STATE OF CONNECTICUT
CONNECTICUT SITING COUNCIL

APPLICATION OF NORTH ATLANTIC TOWERS, LLC
and NEW CINGULAR WIRELESS PCS, LLC (AT&T)
FOR A CERTIFICATE OF ENVIRONMENTAL
COMPATIBILITY AND PUBLIC NEED FOR THE
CONSTRUCTION, MAINTENANCE AND OPERATION
OF A TELECOMMUNICATIONS TOWER FACILITY
AT ROUTE 198 IN THE TOWN OF WOODSTOCK

DOCKET NO. 423

NORTH ATLANTIC TOWERS, LLC and NEW CINGULAR WIRELESS PCS, LLC ("AT&T")
RESPONSES TO SITING COUNCIL INTERROGATORIES SET I

ATTACHMENT 1

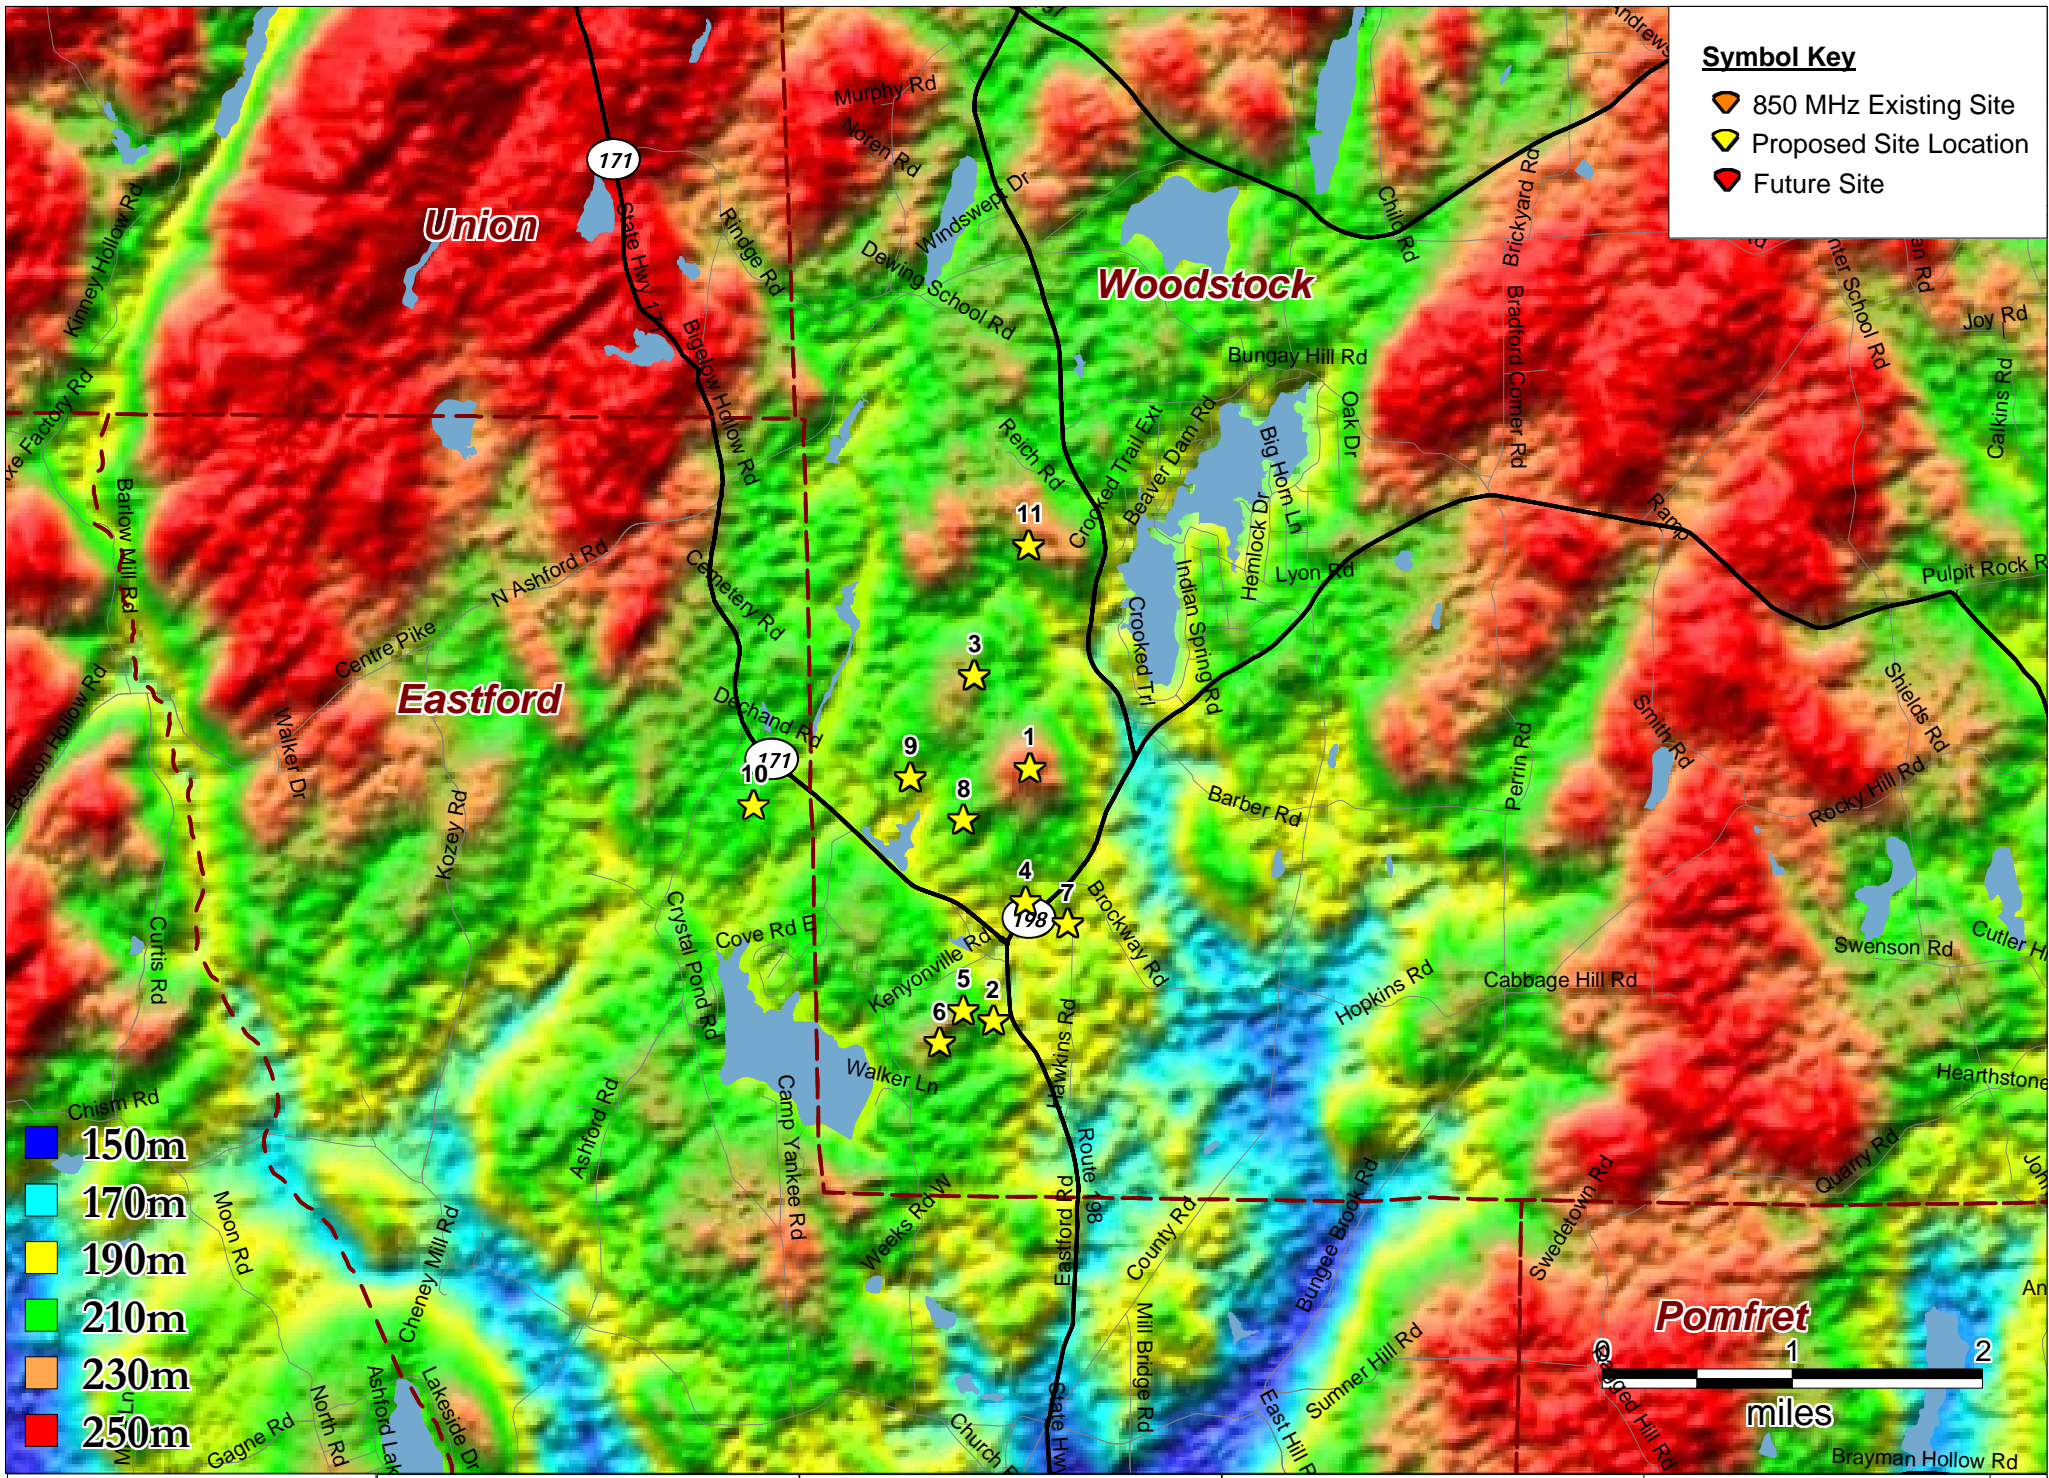
- Q15. Please provide the sites that are part of the Site Search Summary map behind Tab 2 of the application on the 3D Terrain basemap included as Attachment 4 behind Tab 1 of the application.

- A15. Included in Attachment 1 is the 3D Terrain Map with the sites from the Site Search Summary shown.
- Q16. What is the distance and direction of the nearest residence to the proposed tower location? What is the address and owner of that residence?
